TOWN OF AMHERST DESIGN ADVISORY BOARD MINUTES

August 26, 2021
6:00 PM

- 1.1. DESIGN ADVISORY BOARD REVIEW, SP-1983-42 H (BCD); PROPOSED RIDGE LEA BUSINESS PARK PARKING EXPANSION AND FAÇADE UPGRADES, PROPERTY LOCATED AT 4224-4256 RIDGE LEA ROAD
Property Located at 4224-4256 Ridge Lea Road
Benderson Development Company, LLC, Petitioner

TITLE:
Overall
Site Plan

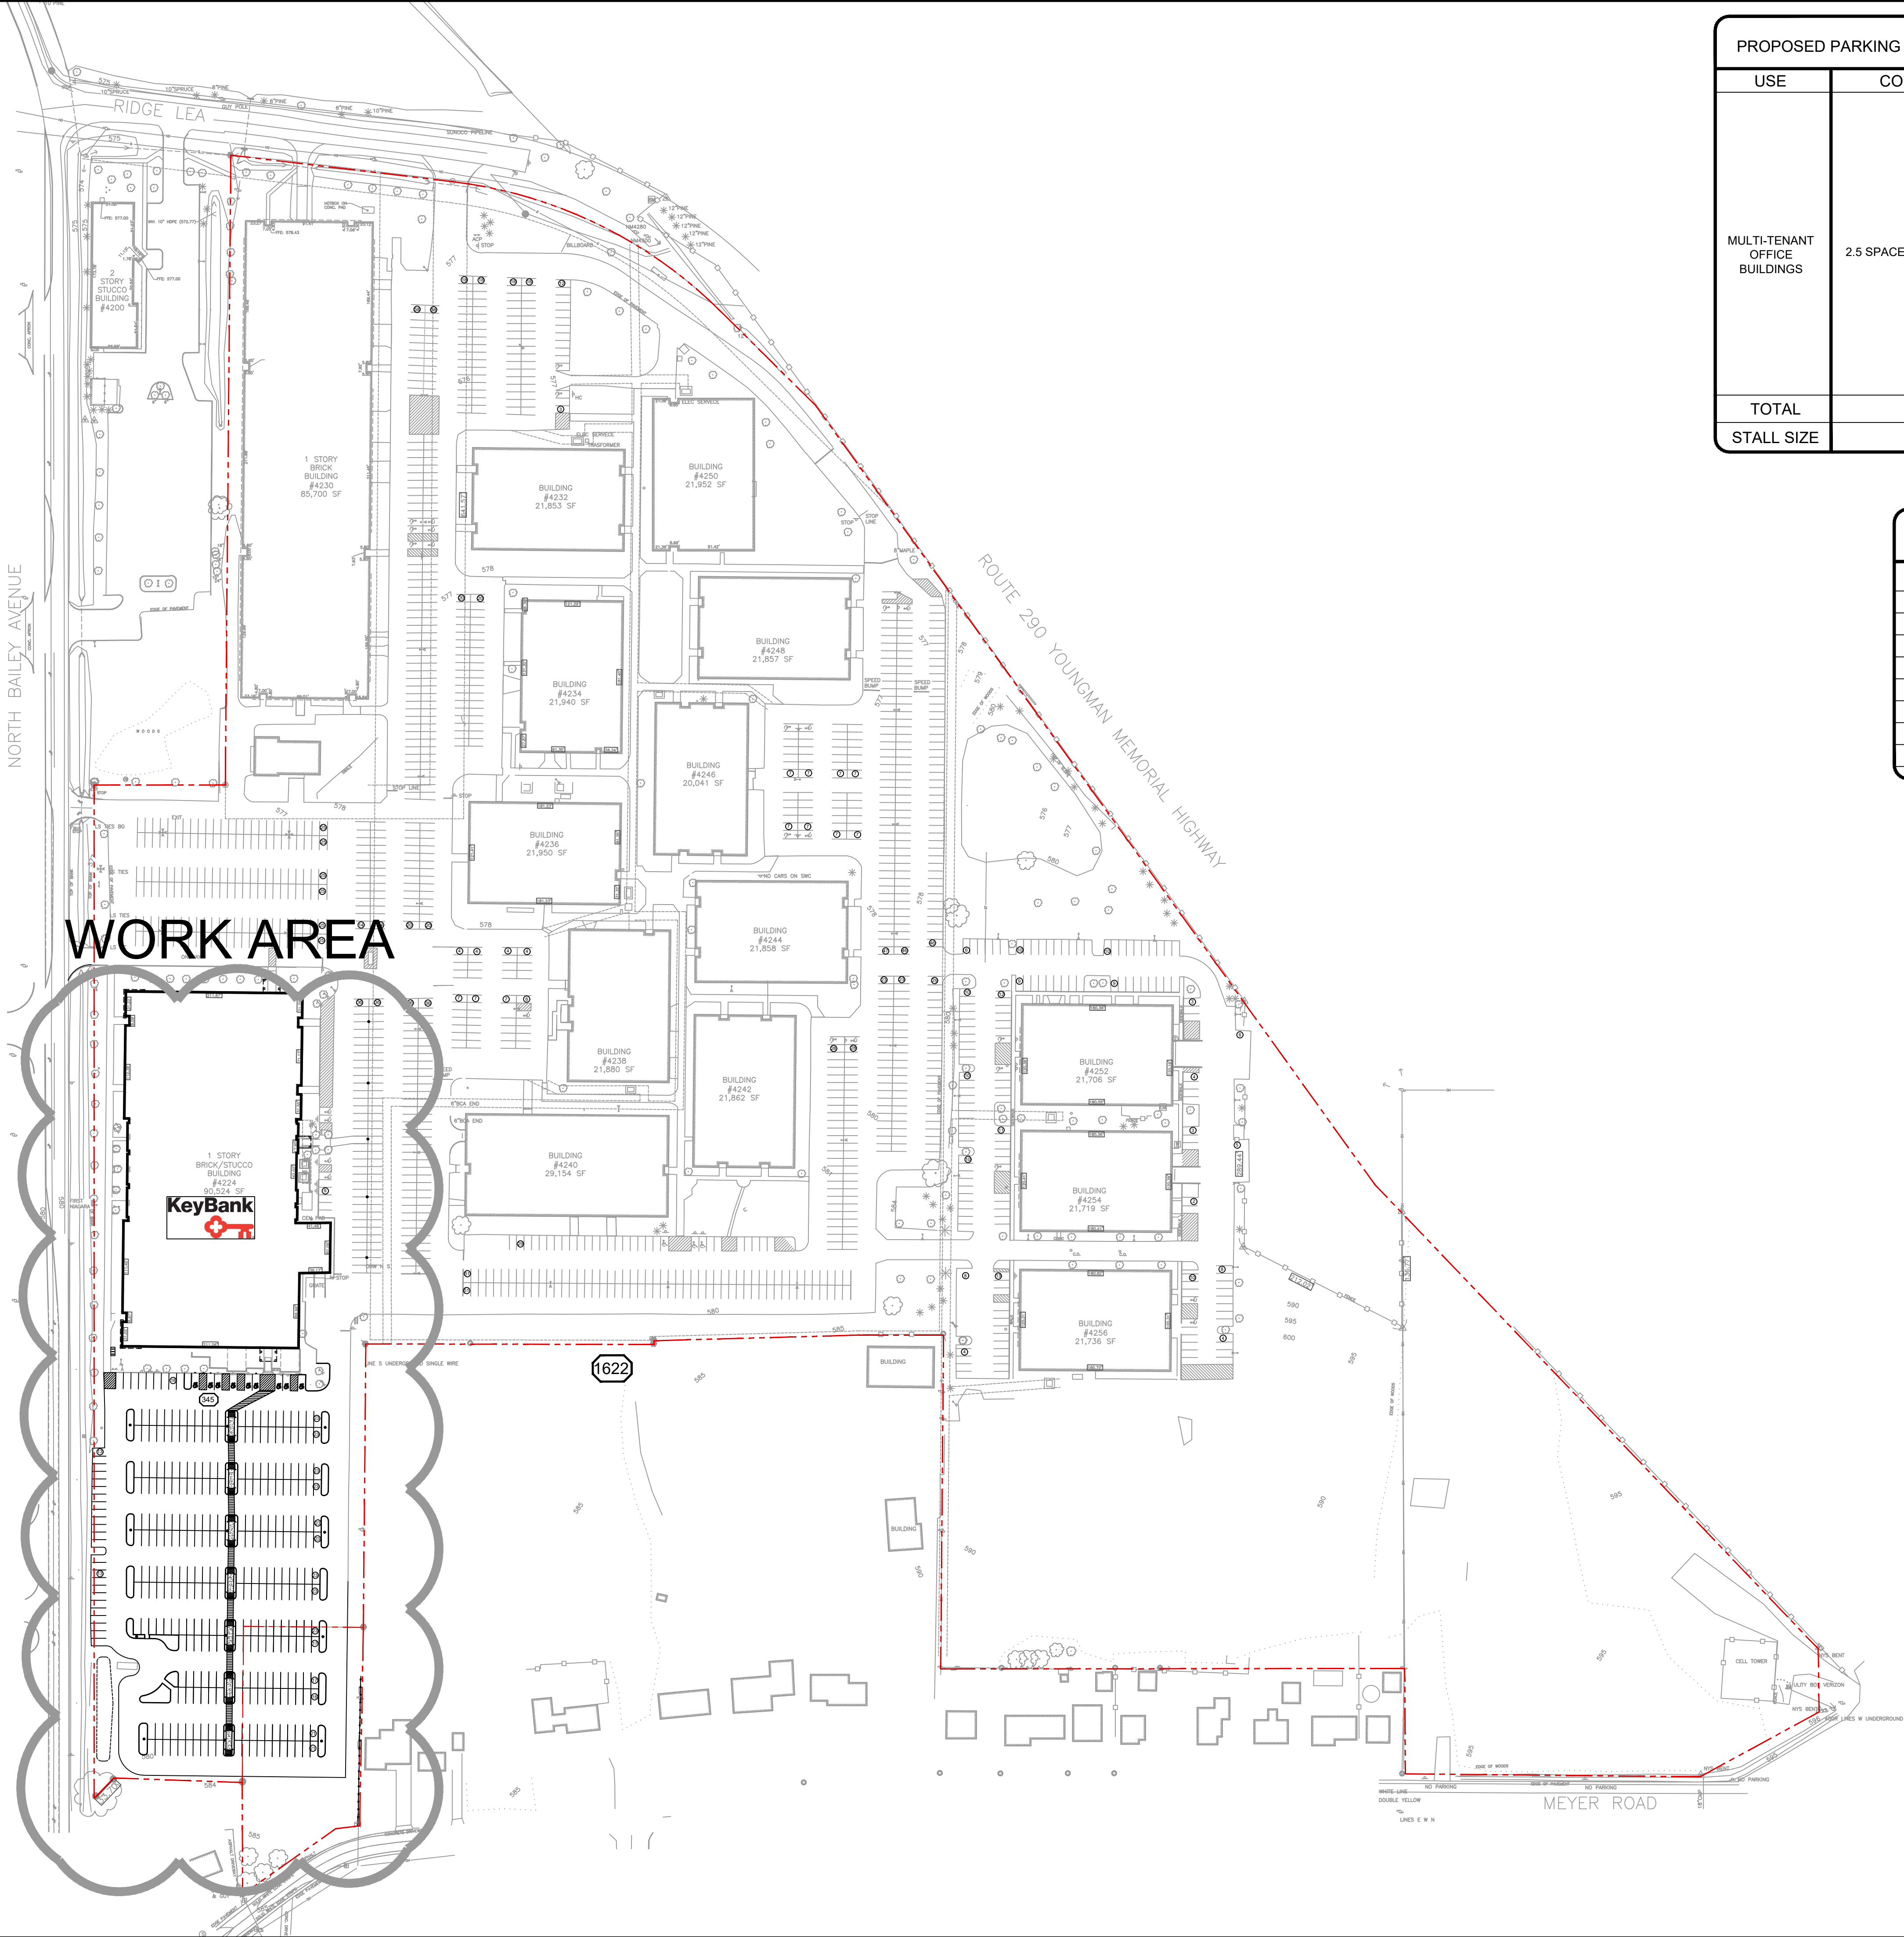
Mr. Talty noted that the sidewalks were not continuous around the entire property. Mr. Boglioli stated that the sidewalk connects to the parking lot and that there is no pre-existing sidewalk along the street to connect to beyond that. Mr. Giuliani confirmed there would be no space to install a sidewalk. Ms. Conhiser-Uy proposed a crosswalk to access the other side of the road but Mr. Boglioli voiced his concerns about the dangers of have a crosswalk mid-street rather than at a corner. Mr. Giuliani pointed out that Benderson could apply for a permit.

- 1) That a pedestrian crosswalk be provided from a point near the northern terminus of the walkways along the west side of the subject building across Bailey Avenue to the public sidewalk on the west side of Bailey Avenue.

TITLE:
Landscaping Plan

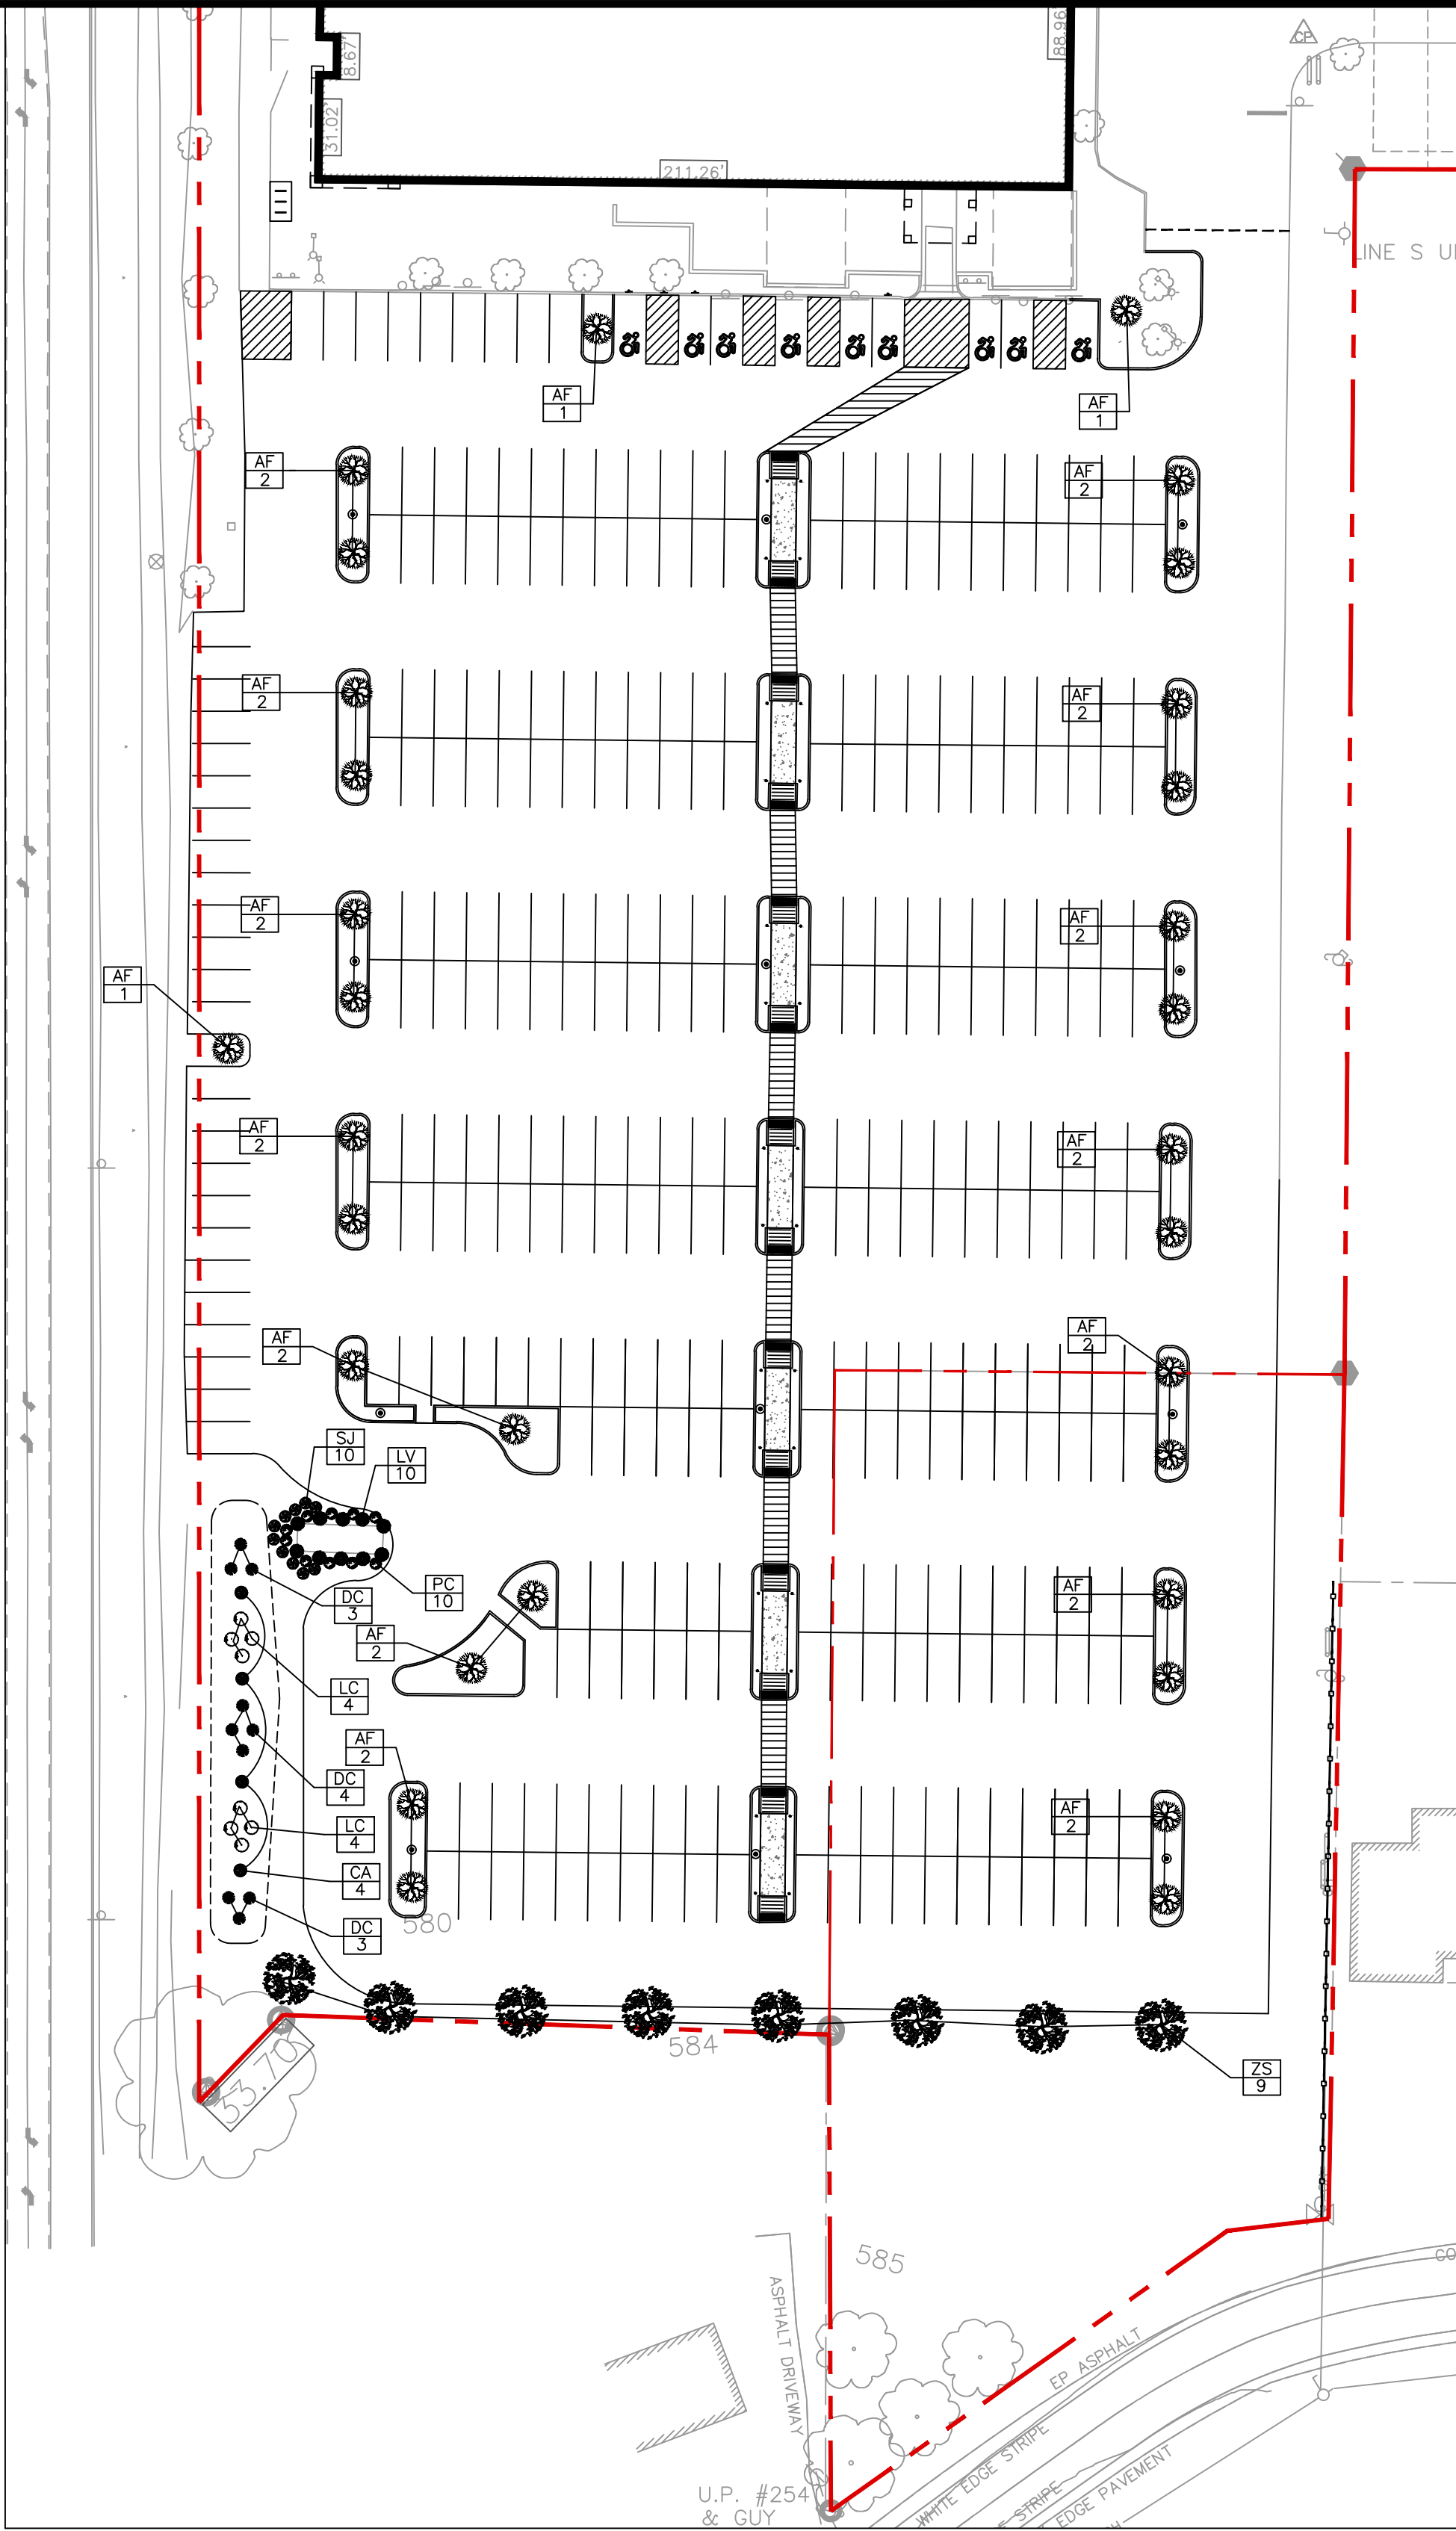
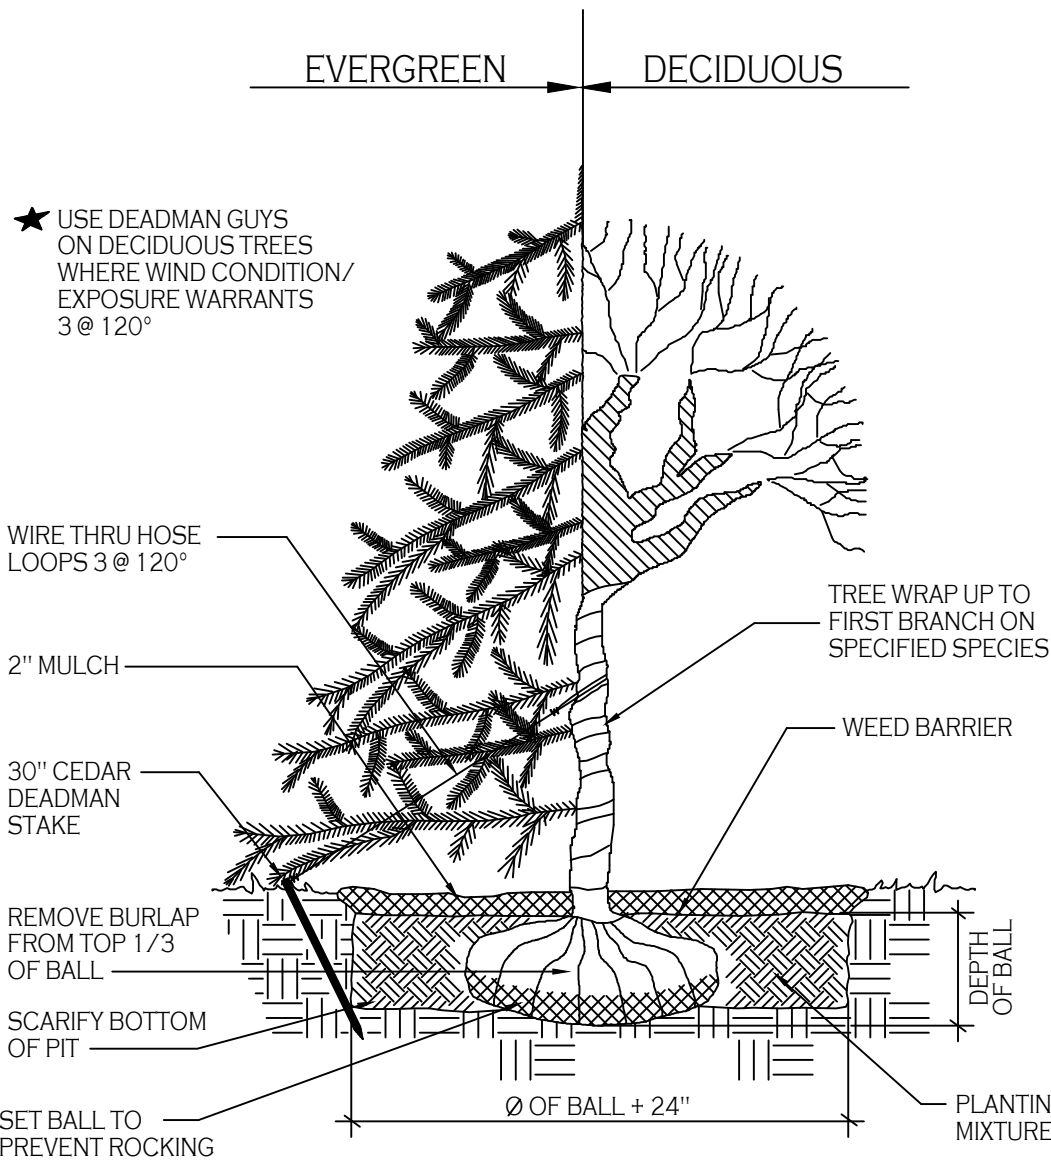
Mr. Boglioli confirmed that the plans showed islands in the parking lot which would add several more trees of various types and more greenery overall.
